**Subject: Proposed Building for Jay Garman
Minor Land Development Plan
Revised Waiver Requests
1267 Risser Mill Road, Mount Joy, PA 17552**

Re: 1267 Risser Mill Road (Jay Garman)
Minor Land Development Plan
Township Permit No. 24-05-MLDP
LCEC Project No: 25-158

**PROPOSED MOTION FOR THE MINOR LAND DEVELOPMENT PLAN
FOR PROPOSED BUILDING – JAY GARMAN
M.J.T.P.C. File # 24-05-MLDP**

DRAWING	EX-1 (2 OF 9)
---------	---------------

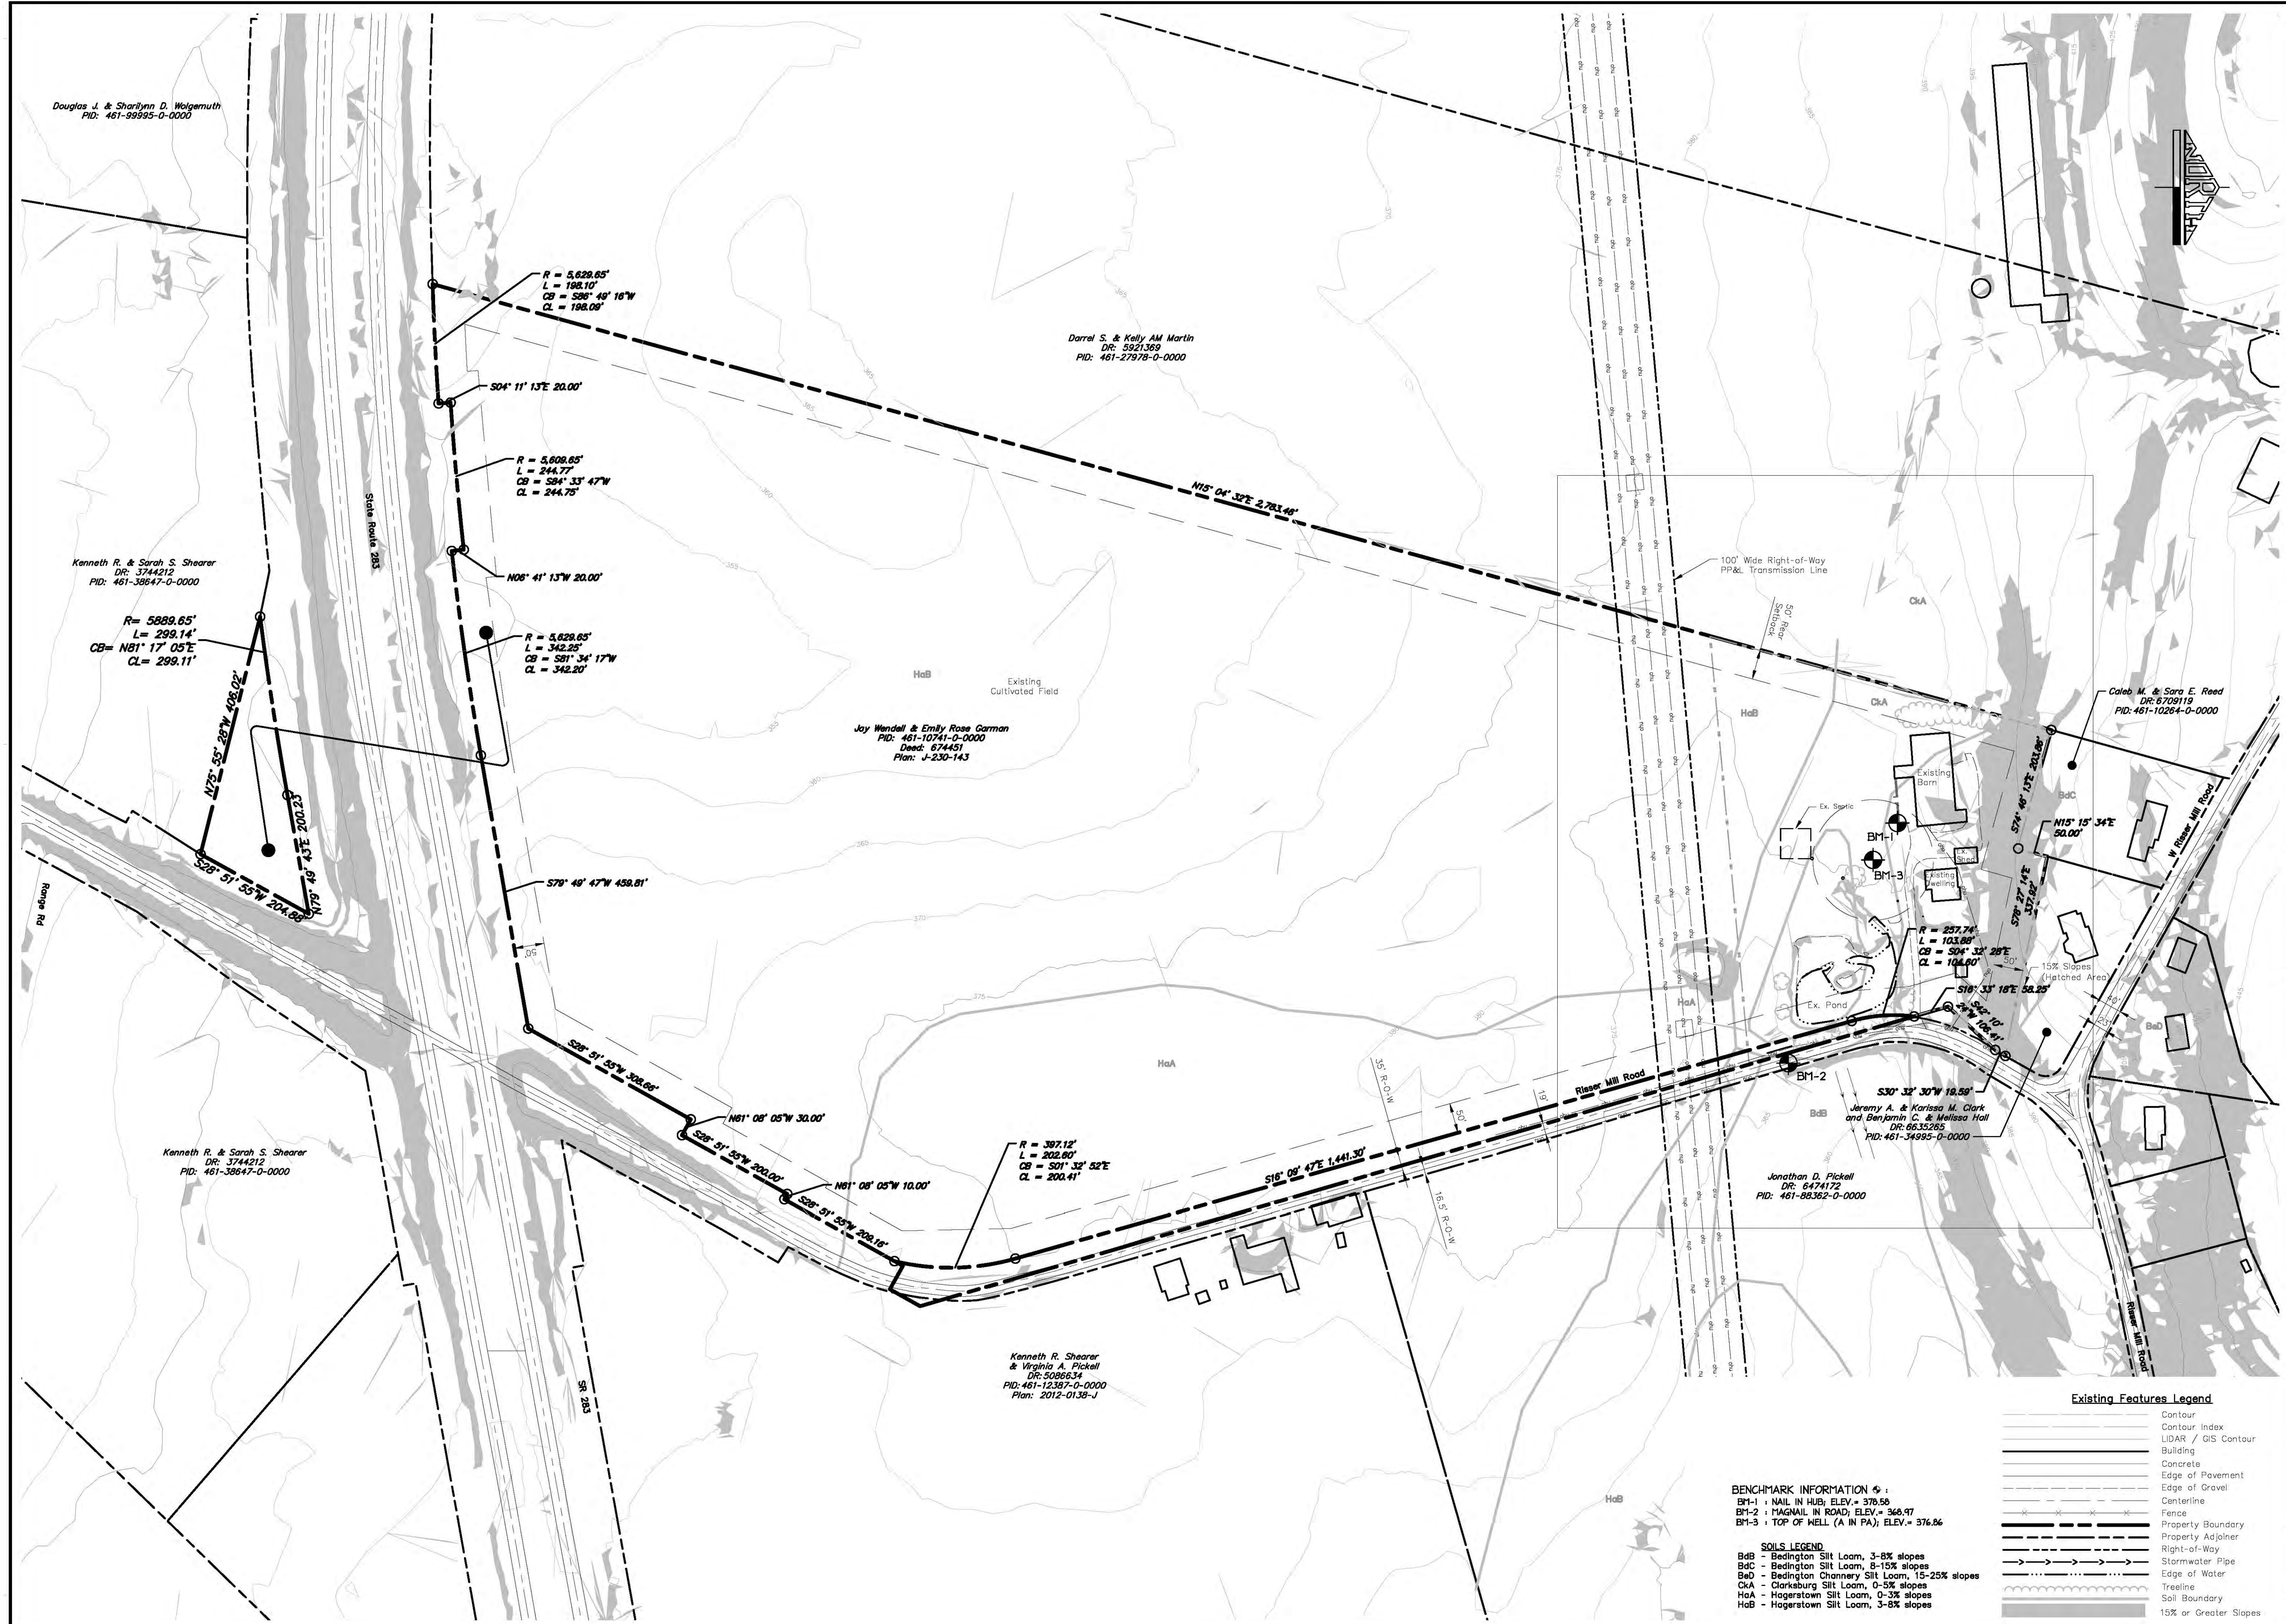
1. **SALDO Section 119-31.A.1 – Plan Scale**

We request a modification of this section to allow the existing features plan to be shown at a scale of 1" = 120' in order to show the entire tract on one plan sheet. Justification is that the required information is that due to the large tract size, we utilize this scale to legibly show the required information and surrounding features.

4. The existing conditions plan shall be shown at a scale between 20 feet and 100 feet to the inch (119-31.A(1)). The applicant has requested a waiver of this requirement.

Modification response: The existing conditions plan is shown at a scale of 120 feet to the inch due to the large tract size. The existing conditions plan is legible and clear. Based on these considerations, I have no objections to a waiver of this requirement.
